Federal Aviation Administration
Aviation Rulemaking Advisory Committee

General Aviation Certification and Operations Issue Area
JAR/FAR 23 Harmonization Working Group

Task 5 – Airframe

Federal Aviation Administration**Aviation Rulemaking Advisory Committee; General Aviation and Business Airplane Subcommittee; JAR/FAR 23 Harmonization Working Group****AGENCY:** Federal Aviation Administration (FAA), DOT.**ACTION:** Notice of establishment of JAR/FAR 23 Harmonization Working Group.

§ 23.441 Maneuvering loads.

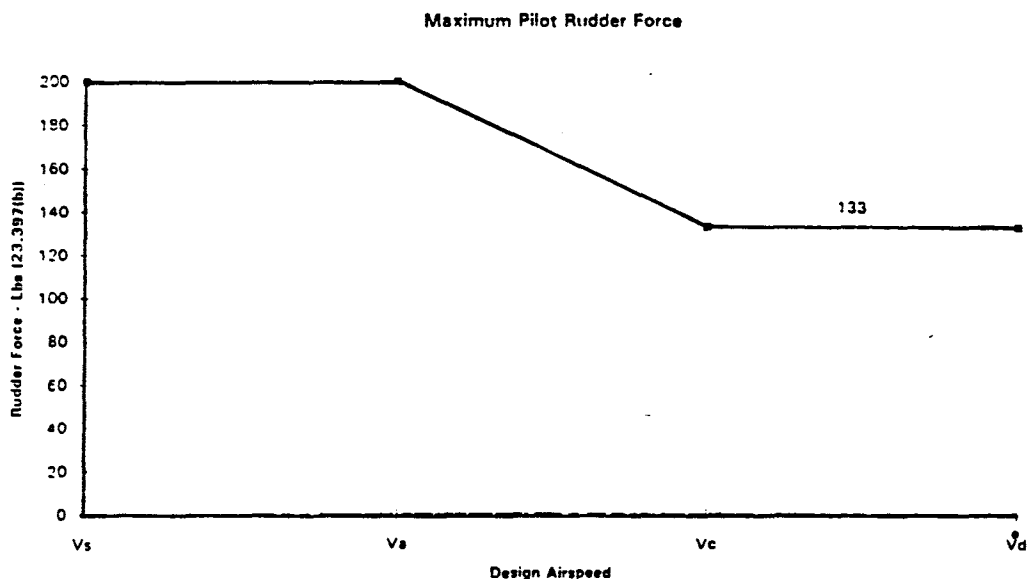
In addition, the permissible overswing angle that may be assumed under § 23.441(a)(2) would be changed from 1.3 to 1.5 times the static sideslip angle of paragraph (a)(3). The JAA informed the FAA that the 1.5 figure more closely represents reality. The FAA agrees and the rule is changed to harmonize with the JAR. Finally, for clarification, the word "resulting" is changed to "overswing" in the first sentence of paragraph (a)(2).

(2) With the rudder deflected as specified in paragraph (a) (1) of this section, it is assumed that the airplane yaws to the overswing sideslip angle. In lieu of a rational analysis, an overswing angle equal to 1.5 times the static sideslip angle of paragraph (a) (3) of this section may be assumed.

FIGURE A7 - CHORDWISE LOAD DISTRIBUTION FOR STABILIZER AND ELEVATOR OR FIN AND RUDDER

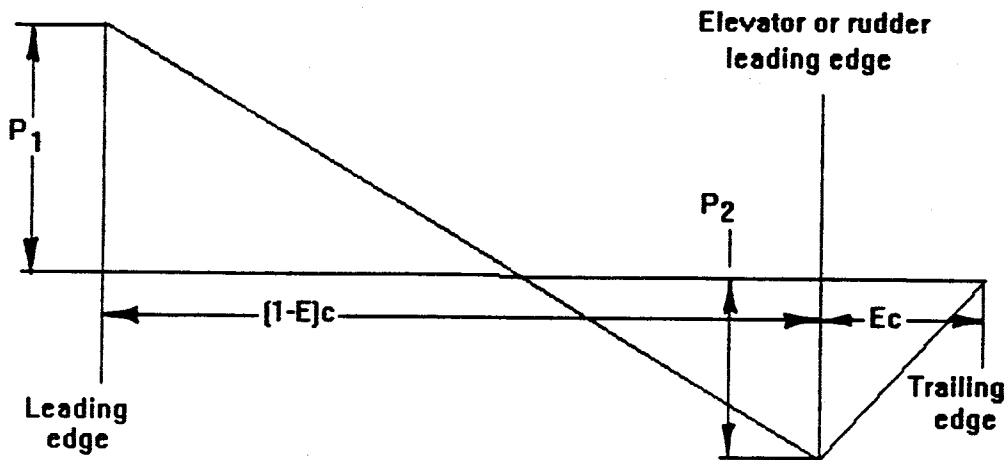
Three areas of Appendix A are revised: (1) A23.1 General; (2) A23.11 Control surface loads, paragraph (c), Surface loading conditions; (3) Table 2 - Average limit control surface loading. A new figure is added to Appendix A: Figure A7, Chordwise load distribution for stabilizer and elevator, or fin and rudder. These revisions are based upon limitations proposed in JAR 23, Appendix A. They are introduced to specify the configurations for which the

The Chordwise Distribution for the Horizontal Tail I portion of Table 2 is deleted and replaced by a "See Figure A7" reference so that a more appropriate design load may be applied. Then, the Vertical Tail II portion of Table 2 is corrected by removing the

A new Figure A7 is added to define both the chordwise load distribution and the corresponding parameters.

$$P_1 = 2 \bar{w} \frac{(2 - E - 3d')}{(1 - E)}$$

- where:
- \bar{w} = average surface loading (as specified in figure A.5)
 - E = ratio of elevator (or rudder) chord to total stabilizer and elevator (or fin and rudder) chord.
 - d' = ratio of distance of center of pressure of a unit spanwise length of combined stabilizer and elevator (or fin and rudder) measured from stabilizer (or fin) leading edge to the local chord. Sign convention is positive when center of pressure is behind leading edge.
 - c = local chord.

Figure A7.—Chordwise Load Distribution for Stabilizer and Elevator or Fin and Rudder

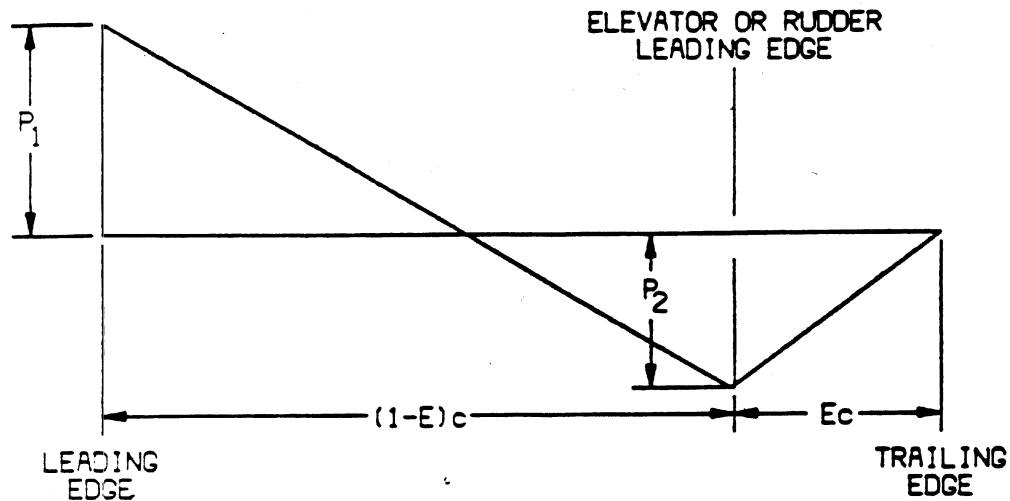
The FAA proposed to revise three areas of Appendix A: (1) A23.1 General; (2) A23.11 Control surface loads, paragraph (c), Surface loading conditions; and (3) Table 2—Average limit control surface loading. The FAA proposed to add a new figure to Appendix A: Figure A7, Chordwise load distribution for stabilizer and elevator, or fin and rudder. The revisions specify the configurations for which the wing and tail surface loads, required by A23.7, are valid. The FAA discovered a need for a clarification change in paragraph A23.a(a)(1) during the post comment review period. The words "excluding turbine powerplants" are clearer than the words "excluding turbines." This revision is included in the final rule to more clearly convey the intended meaning.
